**Basement Impact
Assessment Audit**

NCP Saffron Hill, 14 St Cross
Street, London EC1N 8UN

For
London Borough of Camden

Project No.
14006-75

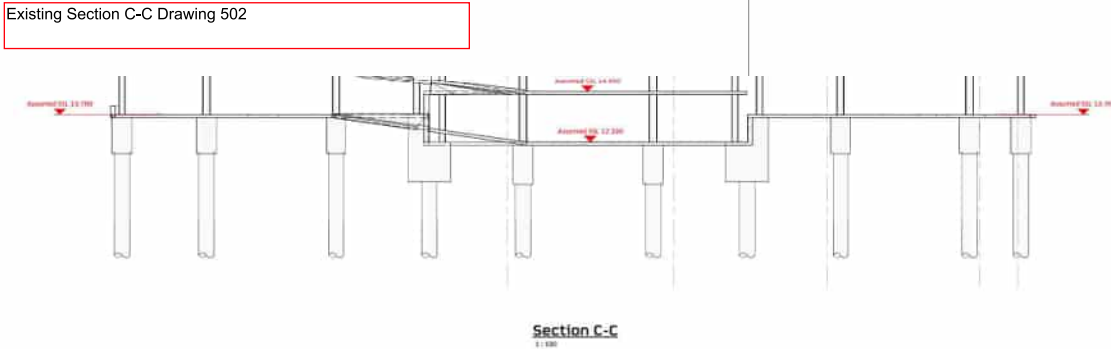
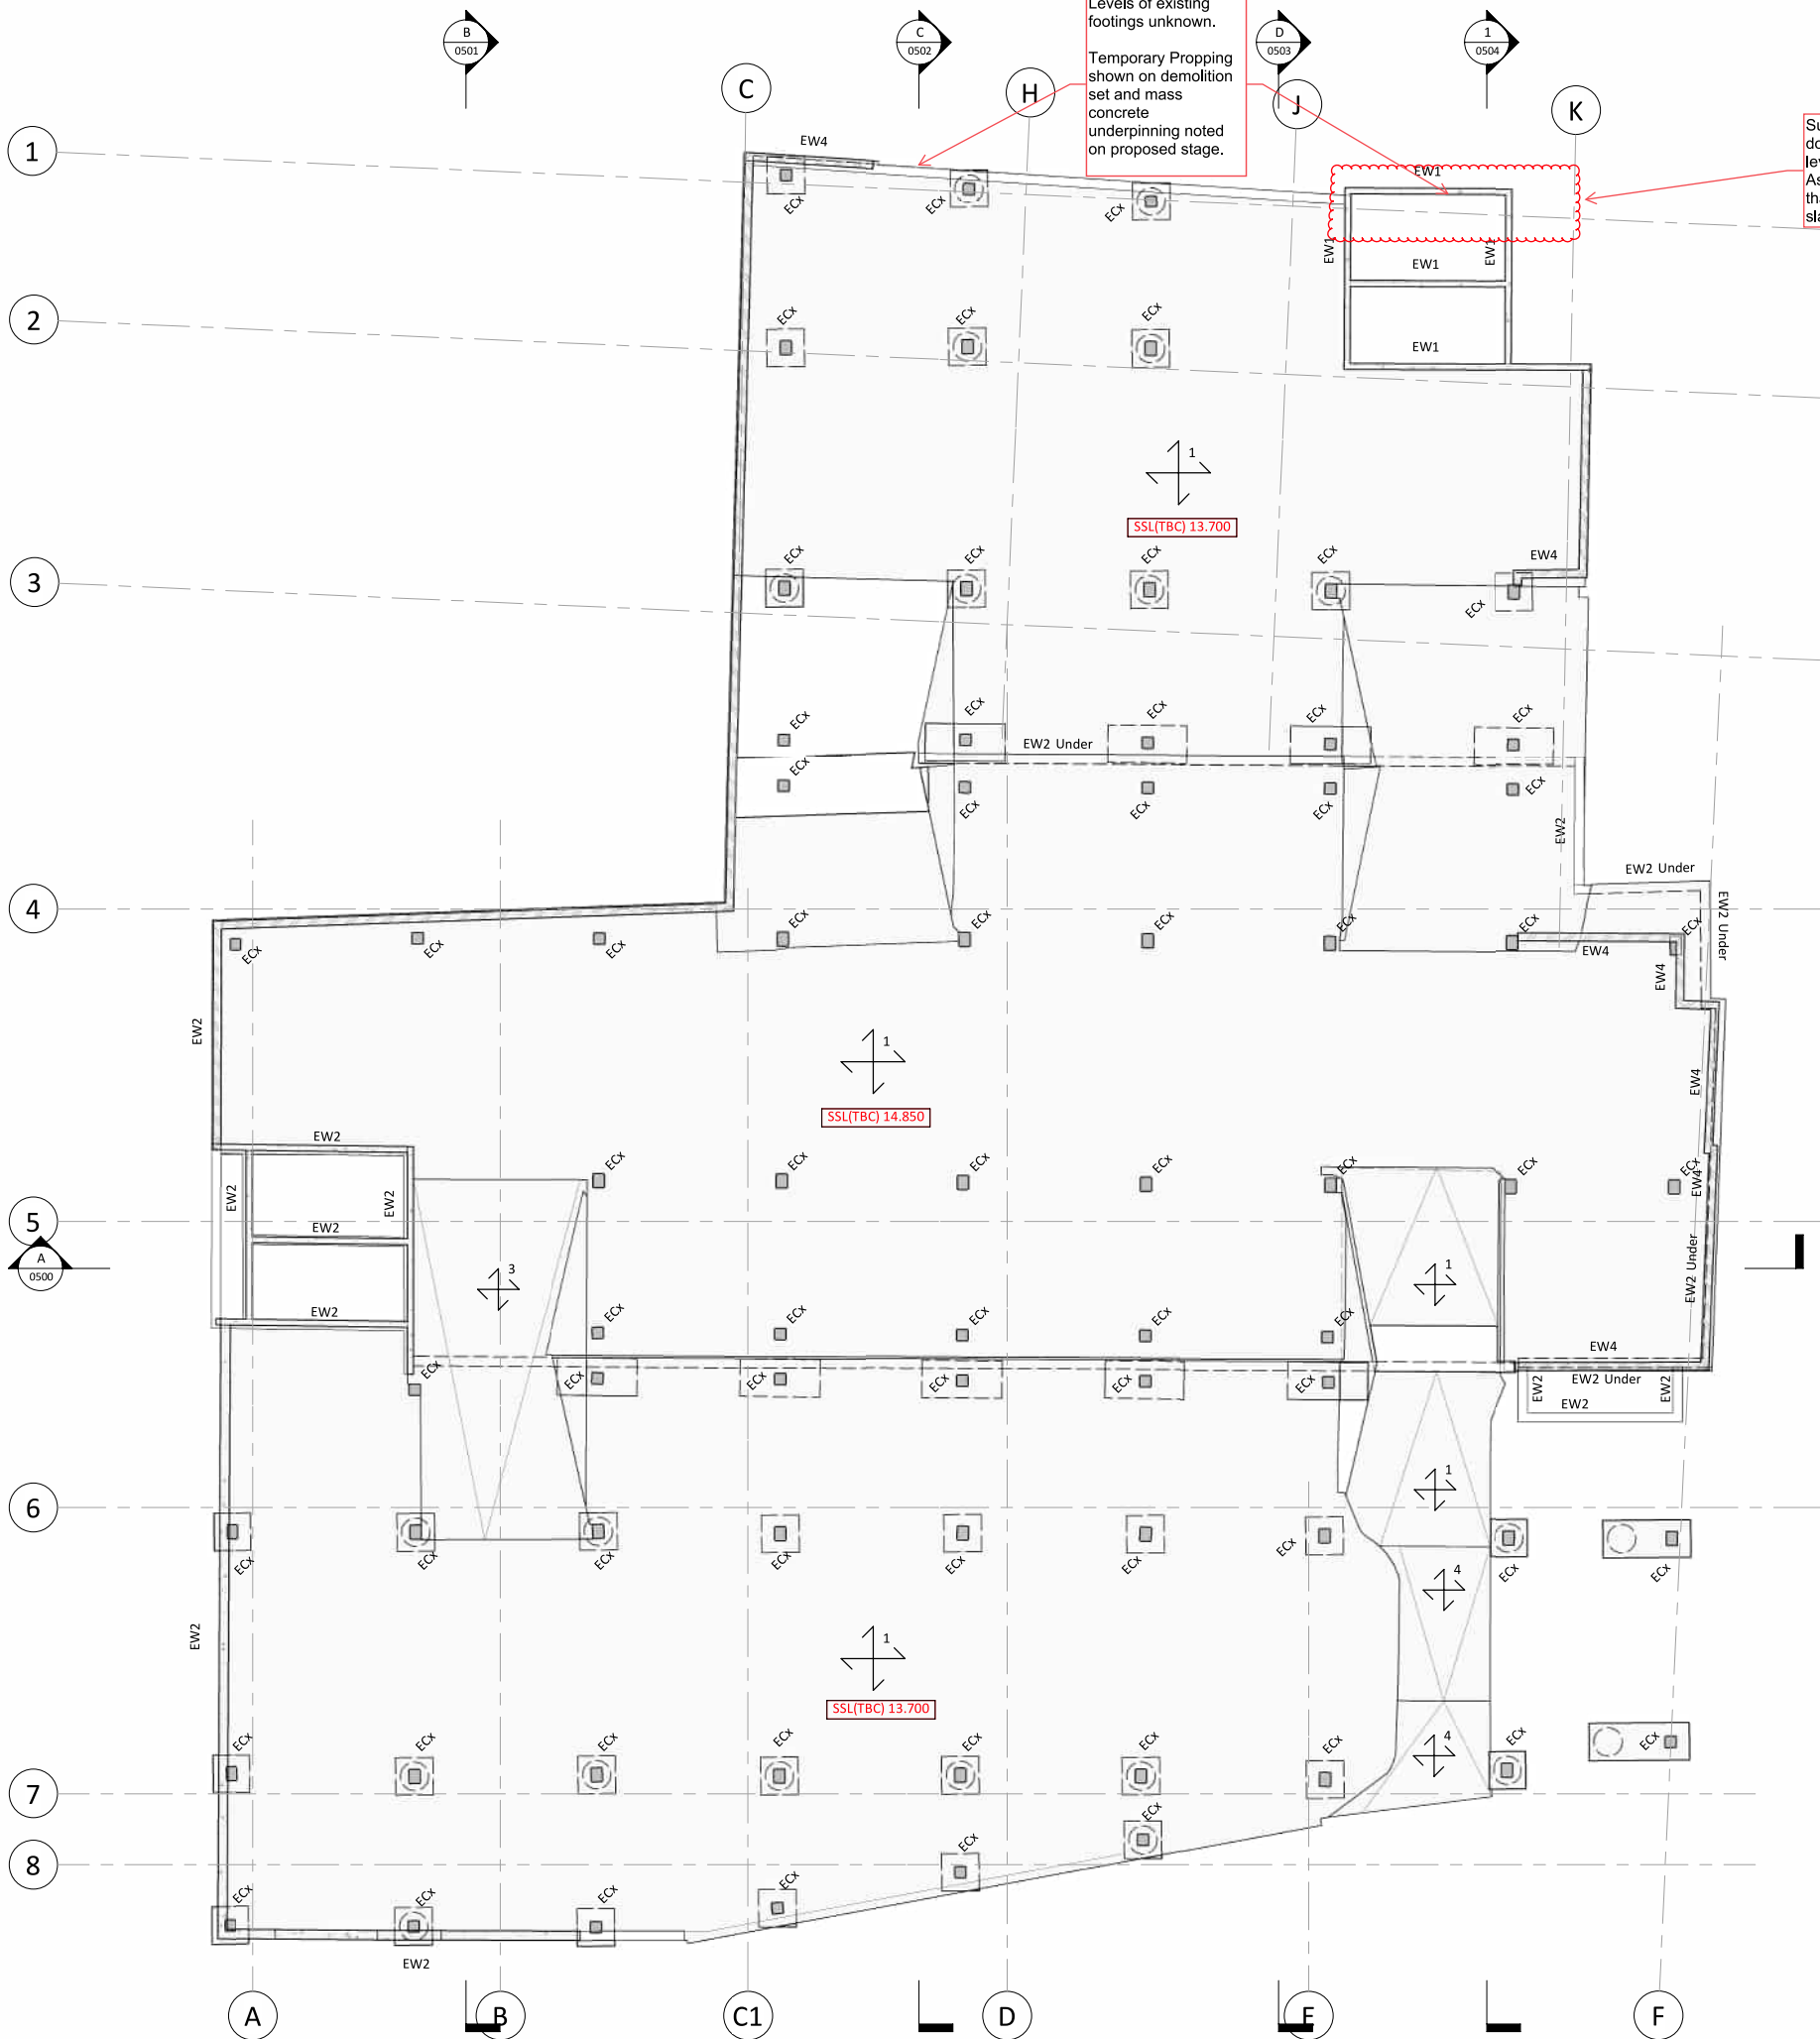
North Elevation/Wall Underpinning

The north elevation wall underpinning is mass concrete to transfer the vertical load to the level of the new LGF. The proposed retaining wall is then formed in front with WRC. The existing wall is propped, as indicated on the demolition drawing SH-HTS-00-00-DR-S-1100, but the existing footing details to the wall has not been confirmed yet as trial pits are due to be undertaken in Stage 3 to confirm depth. An assumed depth has been taken to the underside of the known slab in this area.

Based on the heights noted on section 1 on drawing SH-HTS-00-ZZ-DR-S-3690, it is not expected that this will require two stage pinning, as the working room for mass pins is less than traditional RC pins. This will ultimately be determined by the contractor though. If two stage pins are deemed necessary, an additional line of horizontal propping would be installed in the same sequence as stage 4 noted on SK061.
